## Groundwater Application Review Summary Form

Application # G- 18358

GW Reviewer J. Woody Date Review Completed: 1-3-2018

TO: Water Rights Section Date 1/3/2018  
 FROM: Groundwater Section Jen Woody  
Reviewer's Name  
 SUBJECT: Application G- 18558 Supersedes review of n/a  
Date of Review(s)

Figure 2. Well Location Map

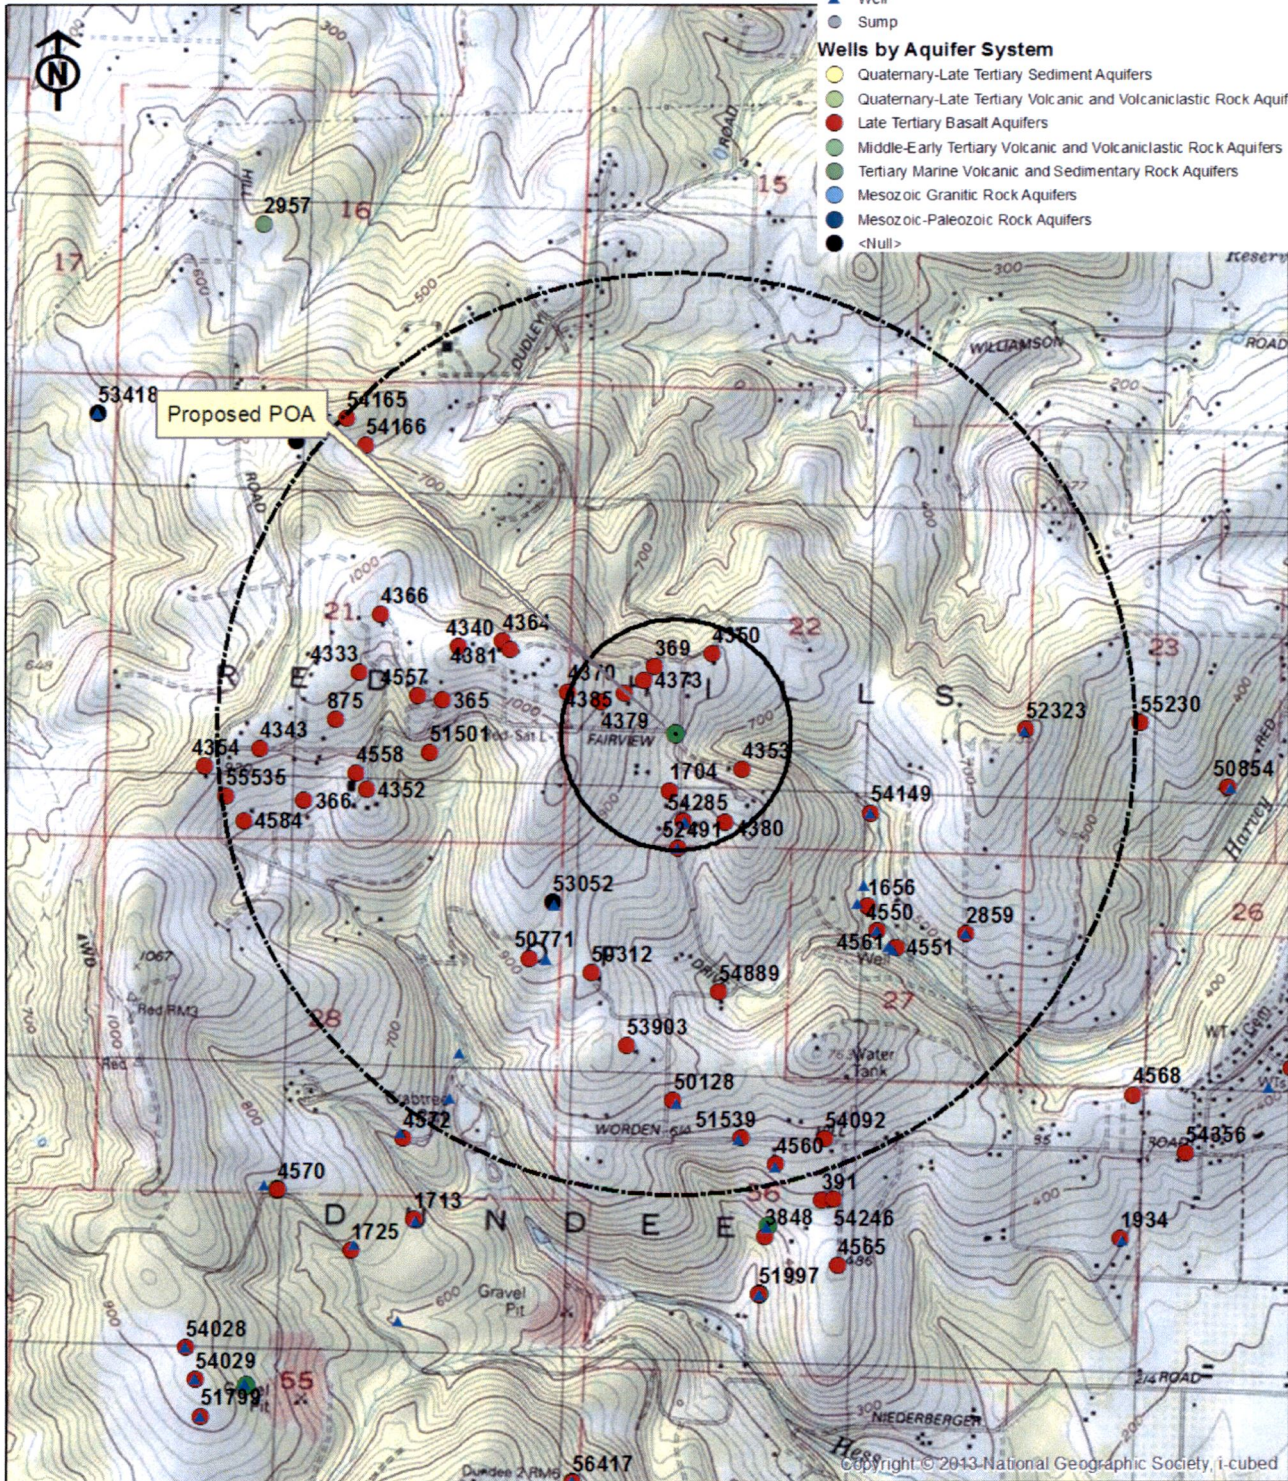
**Basis for aquifer hydraulic connection evaluation:** Nearby creeks have incised through hundreds of feet of basalt. The POA is proposed with a seal from 0-300 feet below land surface. Therefore, the potential for hydraulic connection is examined at the elevation of the top of that open interval. The open interval is coincident with or above perennial reaches of Harvey Creek within one mile, indicating hydraulic connection. Groundwater from the uplands likely discharges to surface water, providing baseflow or spring flow to sustain nearby perennial reaches of the creeks.
